## Response to Editor on "tc-2021-352"

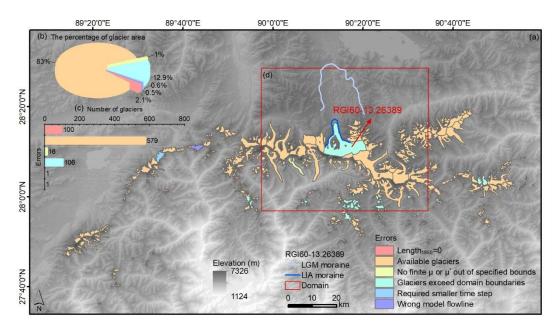
In response to reviewer 2, and following his suggestion, you added a statement saying "Note that the model is unable to capture some small glaciers, which rely on local topography, preferential deposition and redistribution of snow, or avalanching for their existence." However, this is in contradiction to a statement a few lines above, where you say that the number of glaciers is reduced by some exceeding the model domain boundary. This would also be my prime suspicion because of the dependency on beta – and it could relatively easily be mitigated by increasing the border parameter of OGGM. A potential benefit would be that now, those glaciers are missing in your study that apparently show the strongest (relative) length changes (otherwise, they would not exceed the boundary). Including them might increase the clarity of the signal you are after.

Please have a detailed look at what causes OGGM to fail for these glaciers, and adjust the text accordingly (If it is really the smallest of glaciers, you could indicate the percentage of glacier area successfully modeled, in addition to the number of glaciers, so that it becomes clear that despite many glaciers failing in the model, you nevertheless see a signal representative of the region). Depending on what you find, you may decide for yourself whether new models run, with an increased border parameter, are necessary or desirable.

Reply: Sorry for the confusion induced. In this study, we have excluded two kinds of glaciers from our simulations. One is the glaciers that have run out of the simulation boundary and another is the glaciers that have zero length at 1950. The sentence that "Note that the model is unable to capture some small glaciers, which rely on local topography, preferential deposition and redistribution of snow, or avalanching for their existence" is referred to the latter rather than the former. In order to avoid misleading, we have rephrased this sentence into "In addition, more glaciers disappear in 1950 (*Length*<sub>1950</sub> = 0; Fig. 2c) with a larger  $\beta$  because the model is unable to capture some small glaciers, which rely on local topography, preferential deposition of snow, or avalanching for their existence. Although about 100 glaciers will be excluded, they are rather small glaciers which account for only 2.1 % of the total glacier areas (Fig. S3). Therefore, the results are still sufficiently representative for the regional average."

Following your suggestions, we have also increased the border parameter to test whether this method can offset the influence of increased beta. Despite more glaciers can be included when we increase the border parameter, more and more flowlines of the north-slope glaciers are incorrectly calculated (Fig. S3; Fig. R1; Fig. R2). Fig. R3 is a good example. The glacier flowline abruptly changed to a wrong direction when the border parameter is increased from 200 to 400. This will lead to large uncertainties in simulations. Therefore, we still set the border parameter to be 160 to ensure the quality of glacier flowlines.

There are about 106 glaciers exceeding domain boundaries, accounting for 12.9 % of the total area in the MC experiment with  $\beta = -0.4$  and border parameter setting to be 160. Among these glaciers, glacier RGI60-13.26389 contributes most (7.0 %). However, just increasing the border

parameter could not solve this problem because larger domain would lead to wrong flowlines. In addition, setting border parameter to be 160 is large enough for LIA simulation (even large enough for the Last Glacial Maximum (LGM) simulation (Fig. S3d)), according to the mapped glaciers (Fig. 1 and Fig. R3) and previous studies (Qiao & Yi, 2017). We argue that the glaciers which extend out of the simulation boundary are suffered from large simulation bias. Besides, in this response, we have also calculated the GLR and the percentage of available glaciers with different border parameter. The results do not show obvious differences (Fig. S4).
